ECE/TRANS/WP.15/2009/14  
7 August 2009

**PROPOSALS FOR AMENDMENTS TO ANNEXES A AND B OF ADR**

Sub-Section 8.2.2: Certificate of Driver's Training

Transmitted by the Government of the United Kingdom \*

"8.2.2.8.5 *Model for the training certificate for drivers of vehicles carrying dangerous goods*

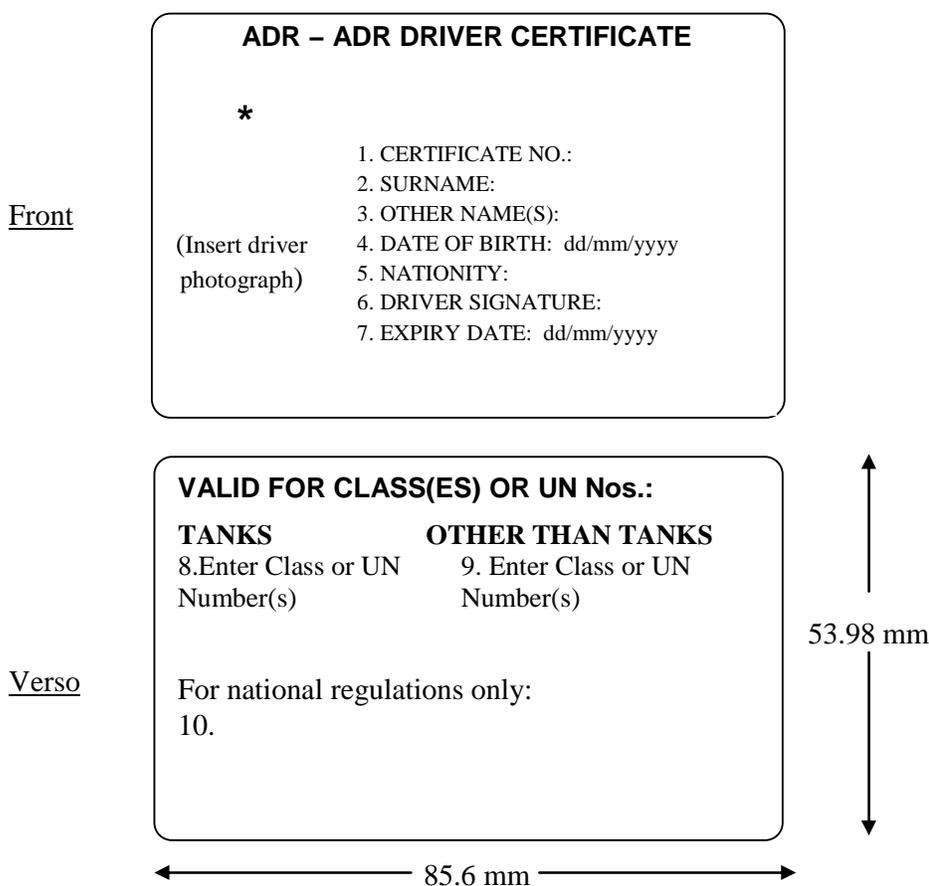
6. The model of certificate illustrated below sets out the data field numbers. It is not proposed that the data field numbers will appear on the certificate only retaining the information in those fields. The recommended harmonised standard layout would enable:

7. The following provides clarification of the data fields proposed in the model of certificate:

- Field 1 – ADR certificate number to be provided instead of driver number – this will provide a unique reference number to the driver, which is life-long, to be quoted in all correspondence;

- Field 2 – Surname – Identifies the ownership of the holder of the certificate;
- Field 3 – Other names – Identifies the ownership of the holder of the certificate;

- Field 4 – Date of birth – We would recommend using the international standard for the date representation formatted as dd/mm/yyyy to align with views expressed at the last session;

- Field 5 – Nationality – The verification will be required for an international document which may assist enforcers to determine any barriers with language;

- Field 6 – Signature – Will provide secondary verification to the enforcement body;
- Field 7 – Expiry date – The use of “valid from” or “date issued” is no longer recommended resulting from varying interpretations. The United Kingdom

recommends using the phrase “Expiry Date” to provide clarity and consistency with other types of international driver licence;

- Field 8 – Training / Examination undertaken and passed for vehicles carrying dangerous goods in tanks – Will verify and validate that the holder of the certificate has participated and successfully passed an examination indicating the scope of validity to the relevant dangerous goods or class(es). The reference to the Division of Class has been removed as recommended by the Secretariat.

- Field 9 – Training / Examination undertaken and passed for vehicles carrying dangerous goods other than in tanks – Will verify and validate that the holder of the certificate has participated and successfully passed an examination indicating the scope of validity to the relevant dangerous goods or class(es). The reference to the Division of Class has been removed as recommended by the Secretariat.

- Field 10 - for National Regulations only or Additional Information –Could include, for example, military dangerous goods training, address of issuing body in case of loss etc.

9. The United Kingdom therefore proposes that the inclusion of a photo on the certificate for drivers carrying dangerous goods would meet national requirements, validation of training for all drivers and authenticity in one single certificate / document. The addition of a photograph on the certificate should provide:

11. Amend 8.2.2.8.5 to read as follows (replaces the amendment in ECE/TRANS/WP.15/201, annex I):
